# WATERLOO METRO QUARTER BUILDING 3&4

SSD-10437 - RESPONSES TO DPIE

PREPARED FOR WATERLOO DEVELOPER PTY LTD  
DOCUMENT NO. WMQ-BLD34-BSA-AR-RPT-DA211

External Elevation

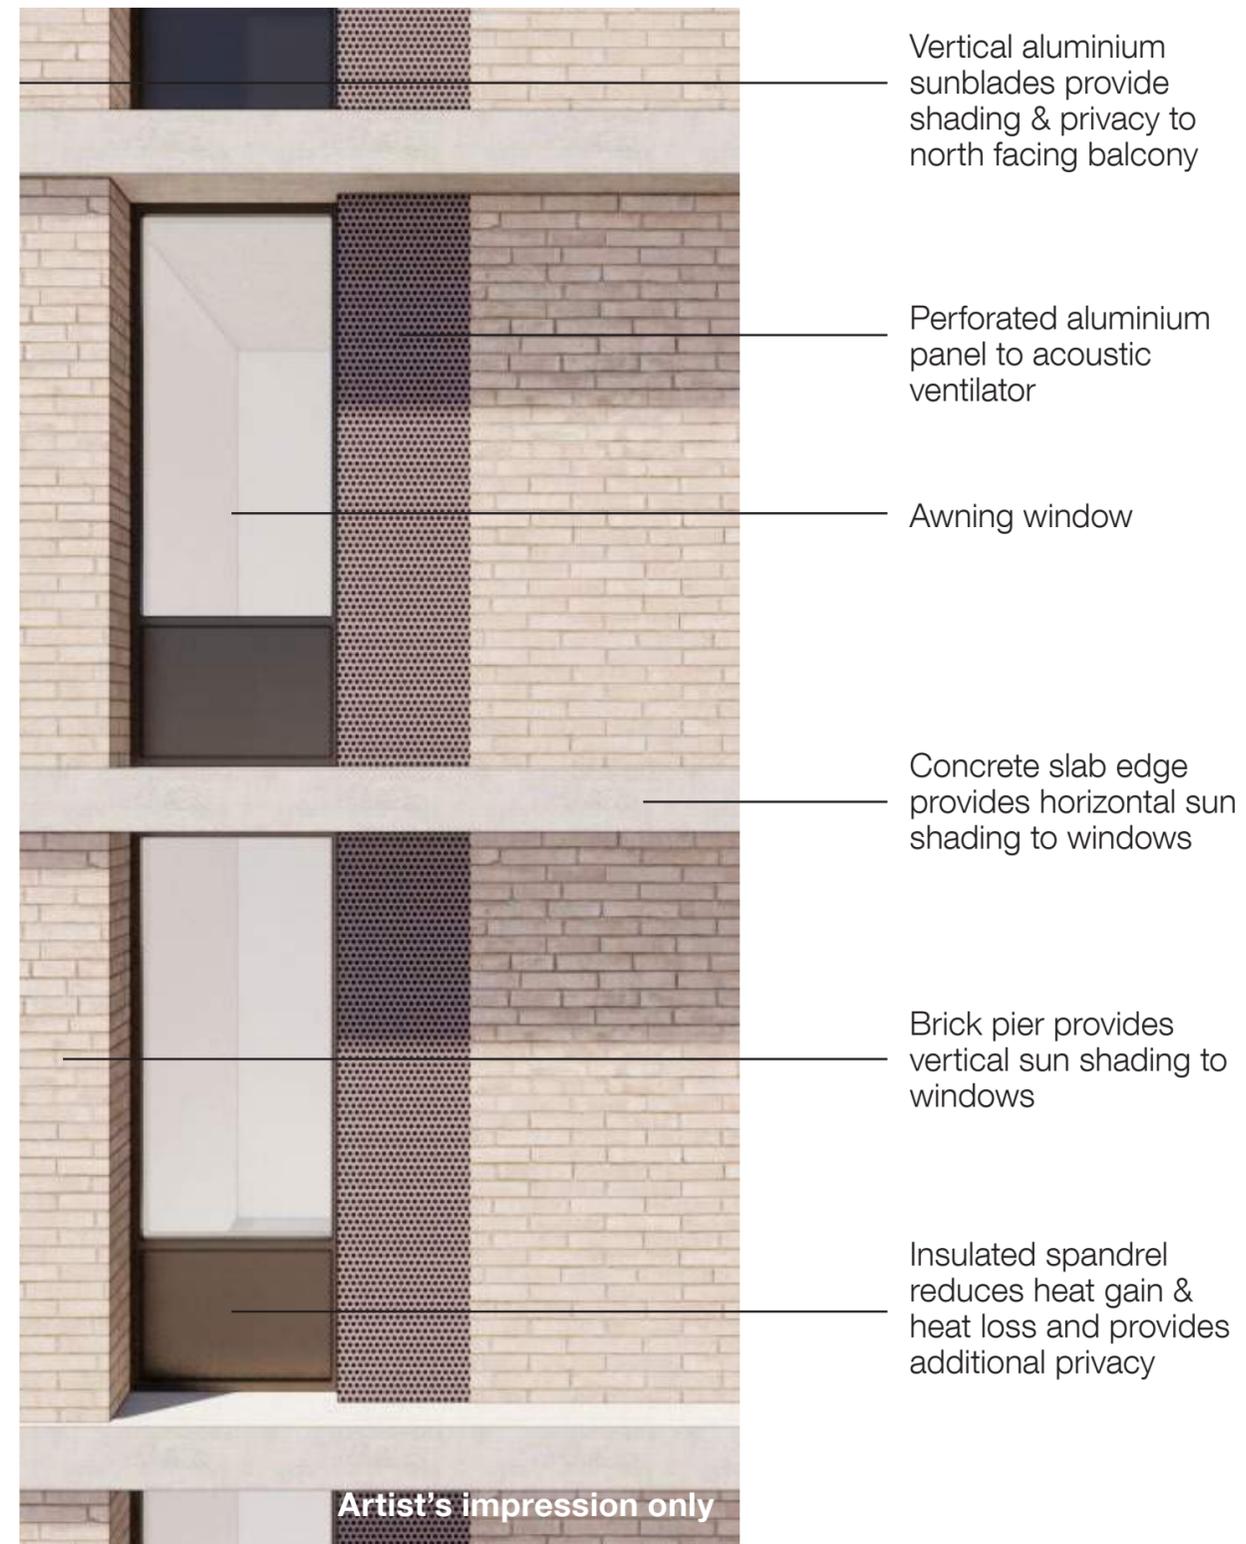
Awning windows provide substandard amenity for occupants by minimising airflow. It is recommended that sashes or casement windows be provided instead. (City of Sydney)

Awning windows have been typically proposed as they enable occupants to open their windows and experience natural ventilation, whilst maintaining weather protection.

A casement or sash window window does not provide the same level of weather protection.

Sashes (double hung) windows are proposed to the windows on the western elevation of Building 4, where the windows are situated behind vertical louvres, and the operation of an awning window is not possible.

3D facade section of the west facing facade

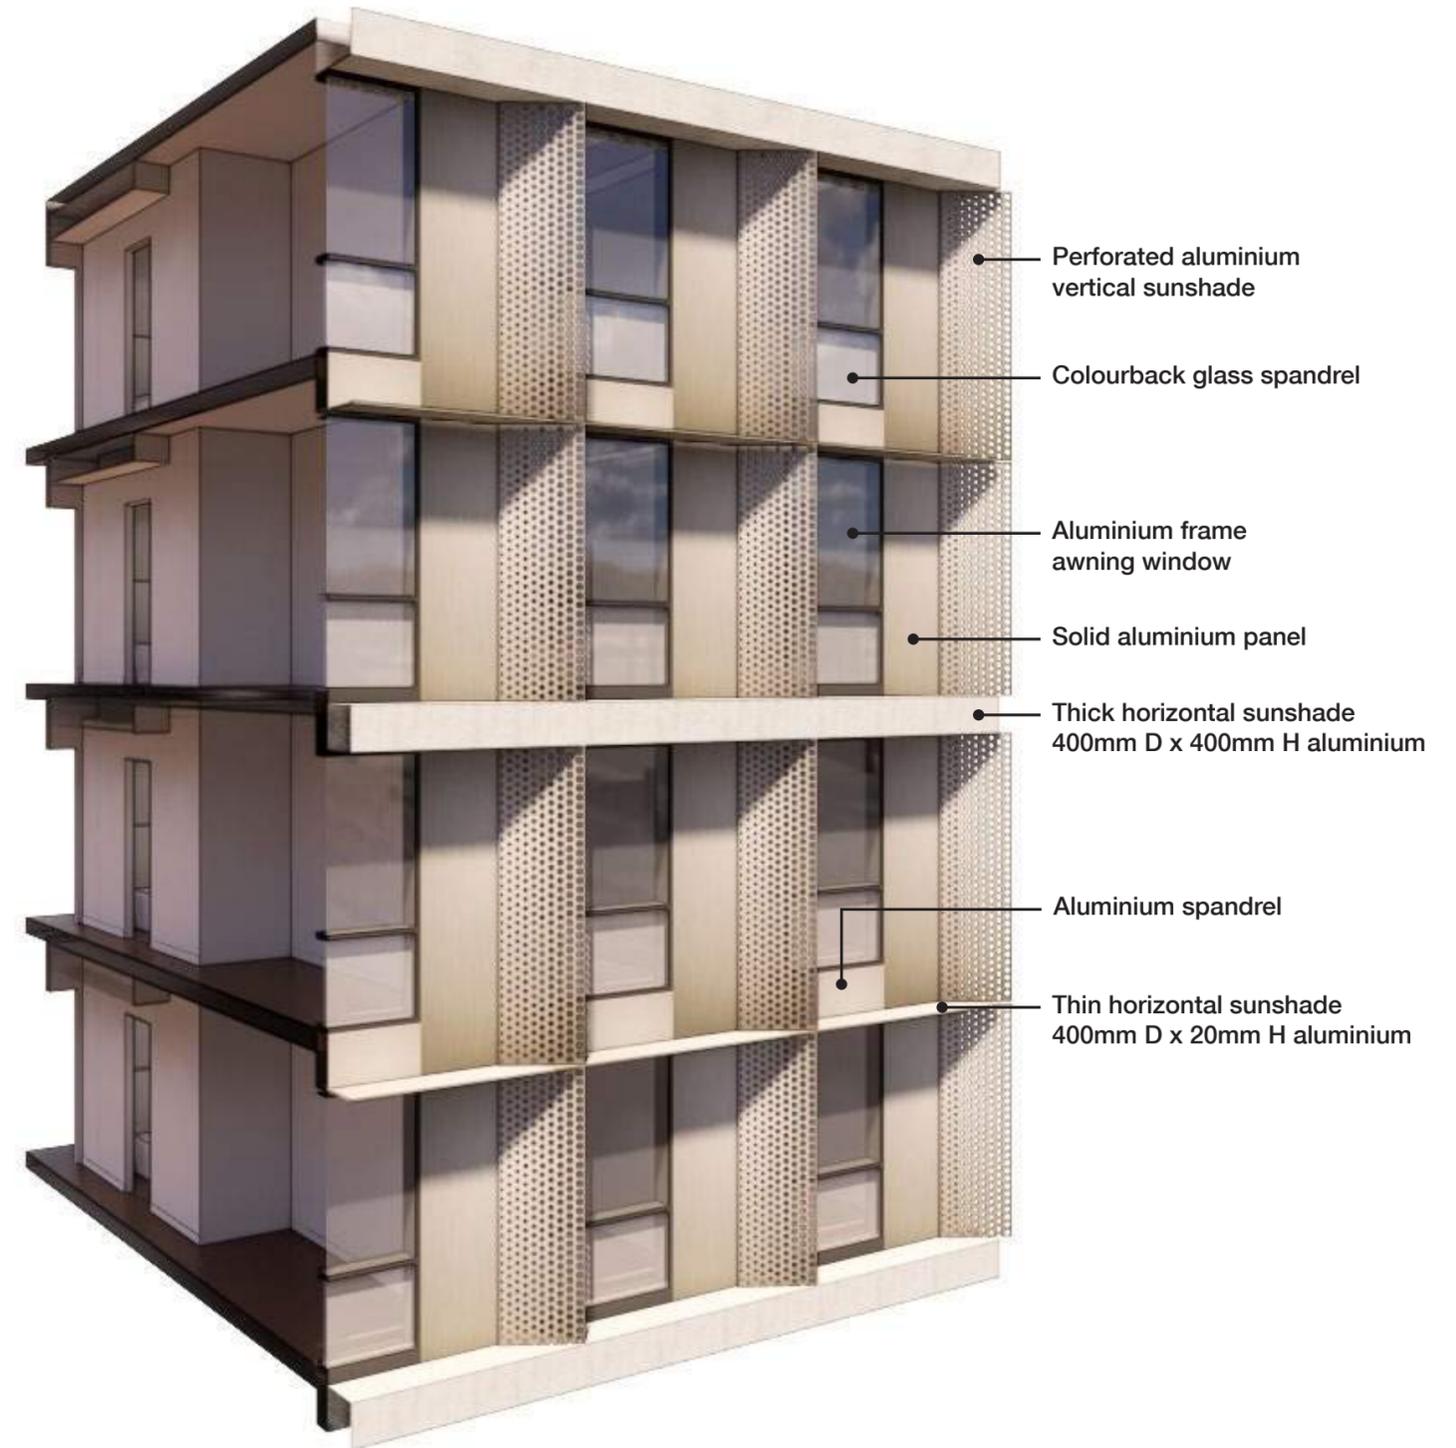
Views from the sun diagrams should be provided at the summer solstice from 8am to 5pm to demonstrate the efficacy or otherwise of the design to mitigate the heat gain from the summer sun.

Individually operable shading devices were considered to the western elevation, but were deemed not practically viable for student accommodation for ongoing maintenance and management reasons. Fixed shading was considered to be more appropriate and cost effective solution to shading the building.

/ The western elevation has a high degree of solidity - the extent of glass to the west elevation is approximately 32%- (i.e the elevation is 2/3 solid)

/ The west facade has a considered response to shading with horizontal sunshades for the early afternoon sun and vertical shading for the middle/late afternoon sun. As shown in the plan below, the vertical shading panel extends in front of the window to further assist in shading

## SHADING ANALYSIS

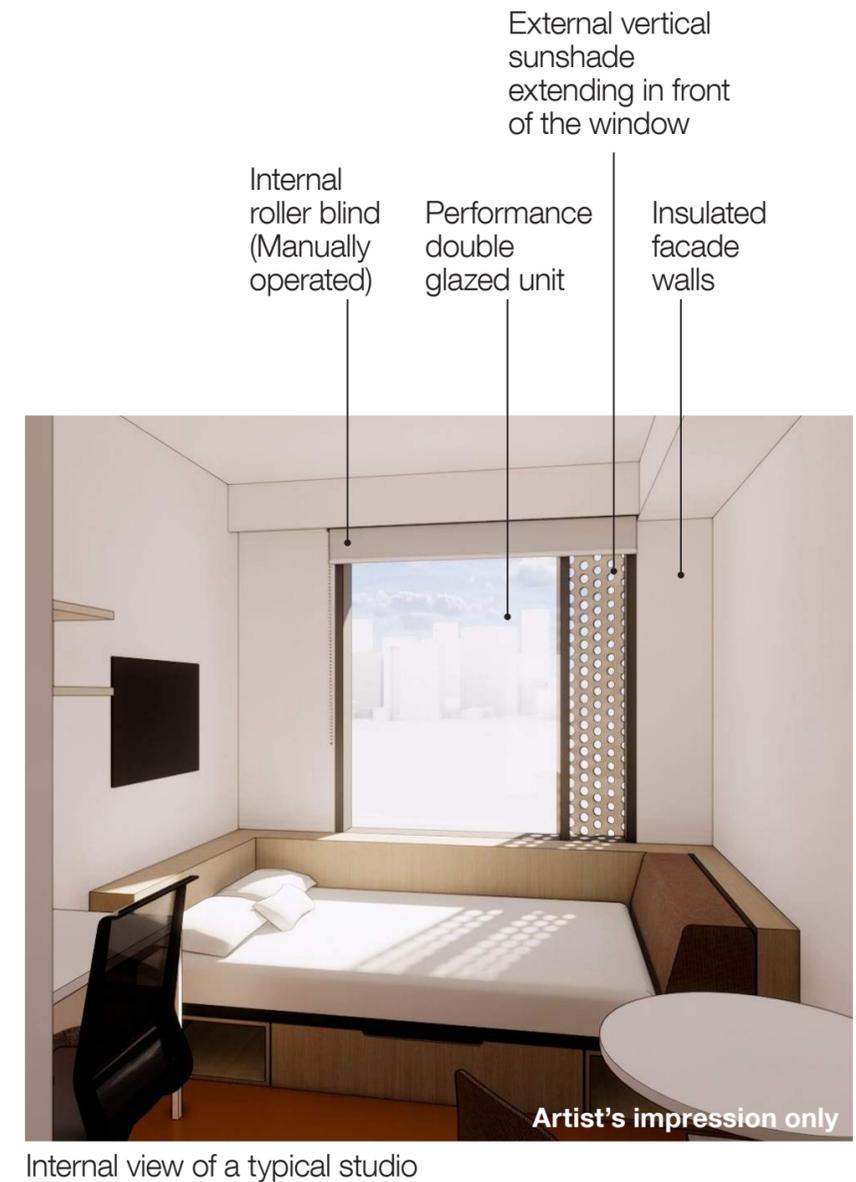
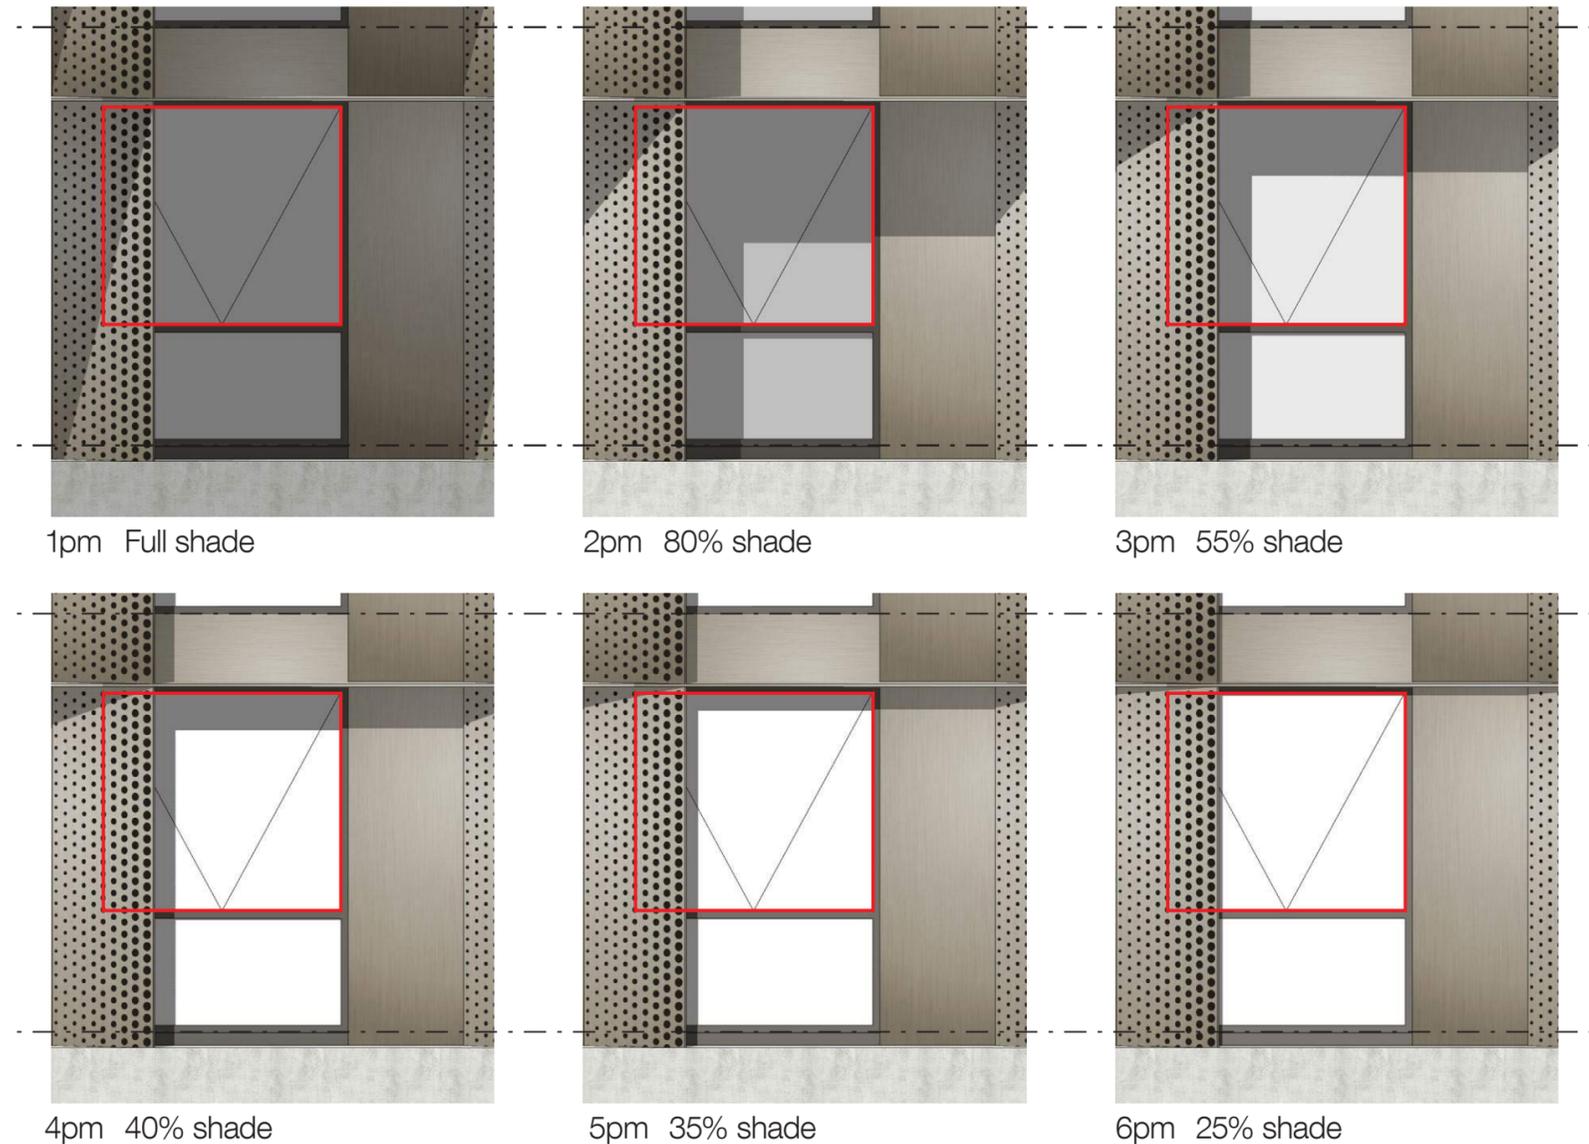
Views from the sun diagrams should be provided at the summer solstice from 8am to 5pm to demonstrate the efficacy or otherwise of the design to mitigate the heat gain from the summer sun.  
(City of Sydney)

The diagrams below were presented at DRP Presentation 12 on 28th January 2021. The diagrams demonstrate the degree of facade shading to the windows on the west elevation of Building 3.

The 'Summernox' (the average of summer solstice and equinox) was considered to be an appropriate method of demonstrating the average efficacy over the full period of summer.
